FB 06
DEPARTMENT OF THE ARMY
HEADQUARTERS, U. S. ARMY GARRISON COMMAND
1733 PLEASANTON ROAD
FORT BLISS, TEXAS 79916-6812

RE: Submittal of Work Plan Comment
Revised RFI Work Plan, Oro Grande Landfill (SWMU No. 20, FTBL-015)
Fort Bliss, Otero County, New Mexico

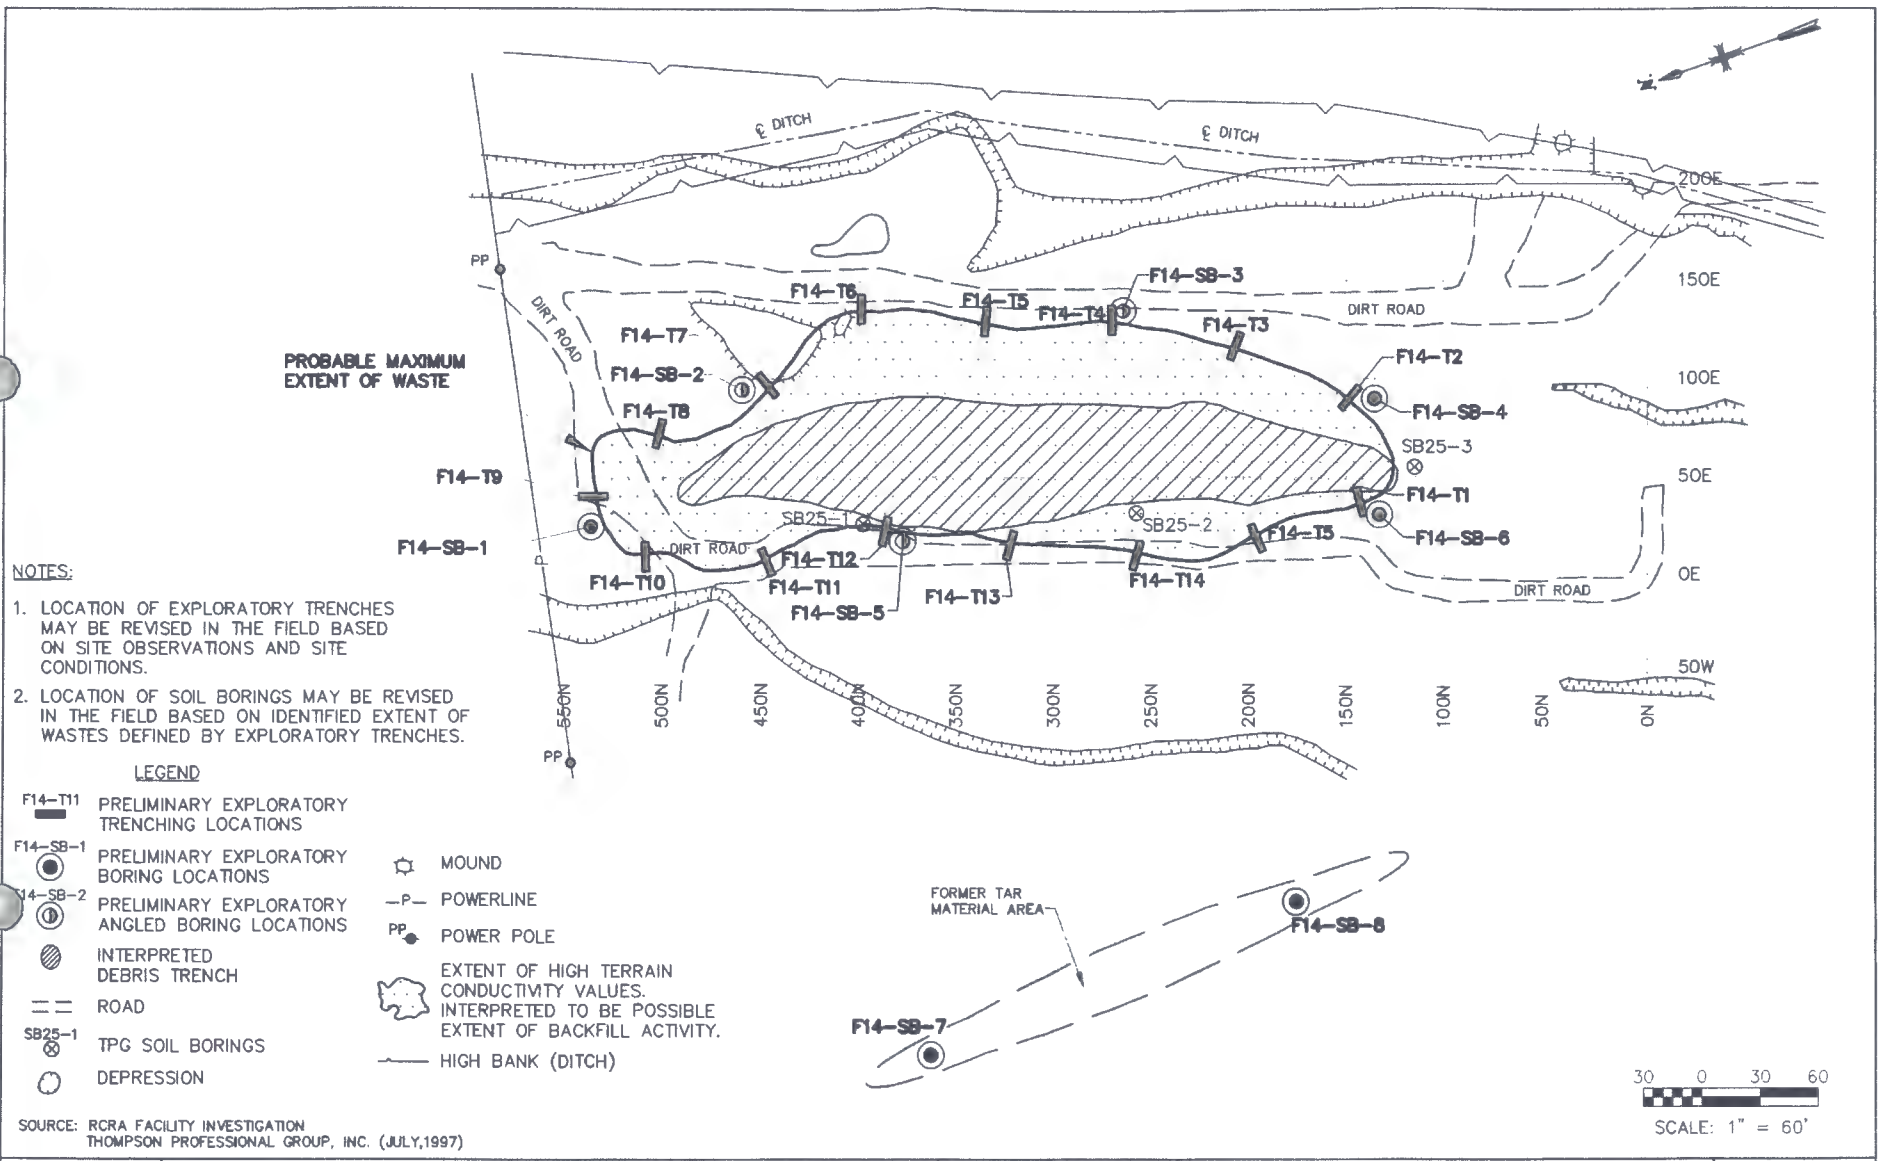
One of the proposed objectives of the Field Sampling Plan is determined whether Contaminants of Concern (COCs) have been released and are present in soils at concentrations greater than residential New Mexico Soil Screening Levels (NMSSLs). Vertical soil borings advanced outside the perimeter of suspected backfill may not be adequate to determine whether COCs have been released to soils beneath the landfill trench.

In order to adequately achieve this objective, Fort Bliss must sample the soil directly underneath the debris trench as described by the hatched area in Figure 4-1 of the RFI Work Plan. Fort Bliss must revise its Field Sampling Plan to include advancing the proposed landfill borings as close to the landfill as possible.

In addition, a minimum of two angled soil borings on the east side and one angled soil boring in the west side of the debris trench must be advanced to minimum depths of 10 feet below, and laterally a minimum of 10 feet underneath the debris trench.

Soil samples must be collected from all soil borings at the surface and at five foot intervals thereafter, to the maximum depths of the borings.

Hollow stem augur drilling techniques can typically attain a 30° angle from vertical. Fort Bliss proposes to drill three directional borings at locations eight feet outside the extent of waste as defined by the exploratory trenching. Figure 4-1 will be revised to show the preliminary locations of these directional borings. The borings will be installed to a depth of 17 feet below the reported depth of waste (12 feet bgs) at a lateral point approximately 10 feet inside the extent of waste. The following text in Section 4.4.1 (p. 4-4, starting second paragraph) will be revised to state:

Malcolm Pirnie will complete three soil borings at locations within five feet of the perimeter of the maximum extent of waste of the landfill defined by the exploratory trenches, three angled soil borings within eight feet of the extent of waste, and two soil borings within the Former Tar Material Area (**Figure 4-1**).

- One soil boring (F14-SB-1) will be installed to a depth of 30 feet bgs on the north side of the landfill.
- One soil boring (F14-SB-4) will be installed to a depth of 30 feet bgs on the southeast side of the landfill.

- Three soil borings (F14-SB-2, F14-SB-3, and F14-SB-5) will be installed at a 30° angle at a location eight feet outside the extent of waste as defined by the exploratory trenching. The soil sample located at a lateral point approximately 10 feet inside the extent of waste at a depth 17 feet below the reported depth of waste (12 feet bgs) will be selected for analysis.

- One deep soil boring (F14-SB-6) will be completed on the south side of the landfill to a maximum depth of 115 feet bgs to assess the subsurface geology and the potential for percolation to the regional groundwater aquifer. This soil boring will be completed five feet into the first clay layer penetrated below 30 feet bgs or 2 feet into the bedrock. Malcolm Pirnie assumes that the first significant clay layer will be encountered within 115 feet bgs. The maximum drilled depth at this location will not exceed 115 feet bgs. Saturated conditions are not expected to be encountered.

- Two soil borings (F14-SB-7 and F14-SB-8) will be installed to a depth of 10 feet bgs in the northern and southern portions of the Former Tar Material Area.
